Application for Licence Amendment

Licence Number	L6315/1991/11
Licence Holder	Water Corporation
File Number	DWERVT16601
Premises	Denmark Water Resource Recovery Facility 33 Hodgson Street DENMARK WA 6333 Lot 965 on Deposited plan 183447
Date of Report	23 October 2024
Decision	Revised licence granted

Figure 2: Distance to sensitive receptors

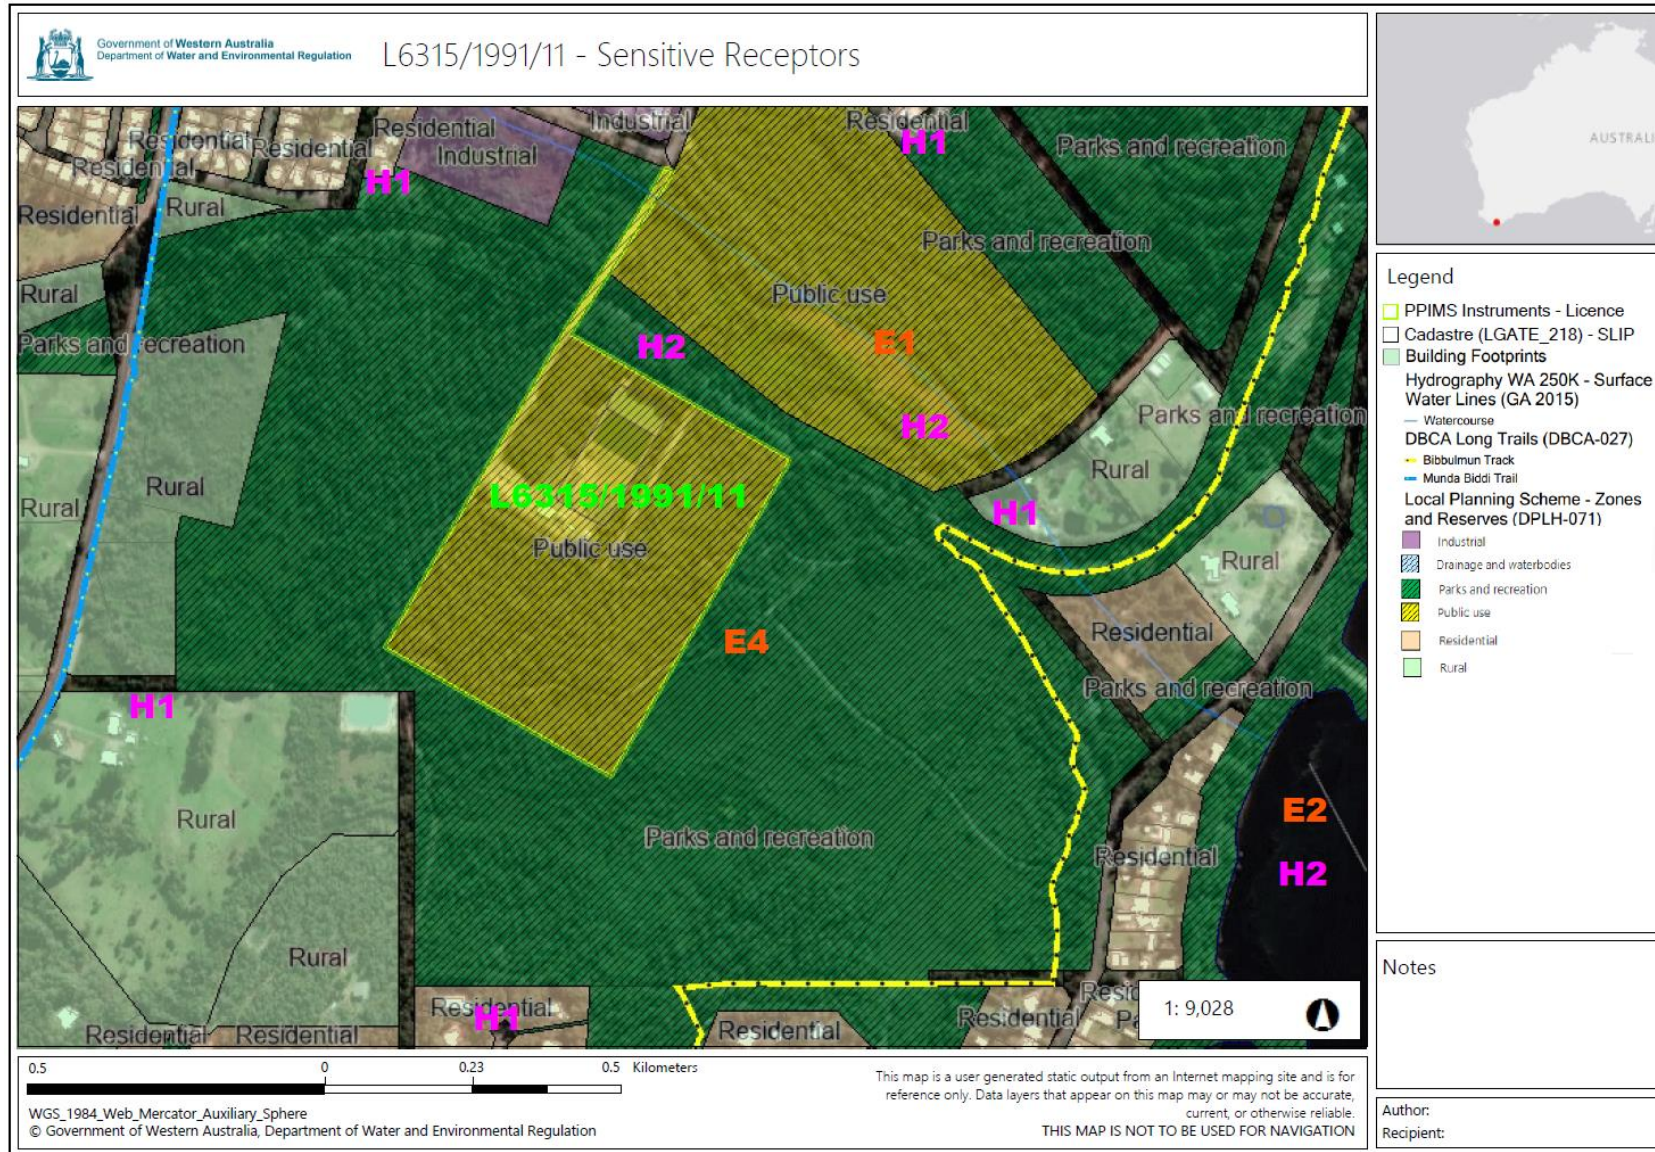
Definitions Table 12	Terms removed as no longer referred to in amended licence: 'Acid Sulfate Soil'; 'Acid Sulfate Soils Guidelines'; 'Environmental Compliance Report'; 'Neutralisation'; 'suitably qualified engineer';
Schedule 1: Maps Premises Map	Figure 1 updated to include R1 monitoring point, remove 1/09 groundwater monitoring bore and include 2/20 monitoring bore.
	Figure 2 updated to include R1 monitoring point and remove reference to 'proposed' new structure and pipework which has now been constructed.
	Figure 3 deleted as information now provided on updated Figure 1 and Figure 2.
Schedule 2	Deleted '25' numbering as unnecessary.

and Figure 2.		
Condition 9, Table 6	-	Footnote is yet to be added under Table 6 relating to superscript 1. (Assuming this relates to in field non-NATA testing being permitted).	Amended as per comment.
Condition 18, Table 10	Condition 9 and 10 Error! Reference source not found	Correction of cross reference error.	Amended as per comment.
Definitions, Table 12	Include: Discharge point R1 Means the treated wastewater discharge point from the Premises authorised under this licence, being the Reuse Transfer Pumps as depicted in Schedule 1.	Given L1 has a definition, this wording is proposed for R1 if it needs to be included. Note Table 12 should become Table 11 given the removal of the construction section which previously had table 11.	Definition for 'discharge point R1' included.
Footnote	L6315/1991/11	Correcting typo of Licence number in footnote.	Amended as per comment.
Schedule 1, Figure 2	Replace figure with corrected version	We identified a minor error in the site schematic where it's missing the flow path from the transfer tank to the discharge diversion manhole. A corrected version of the schematic has been included as an attachment to these comments.	Figure 2 replaced with corrected version provided by Licence Holder.
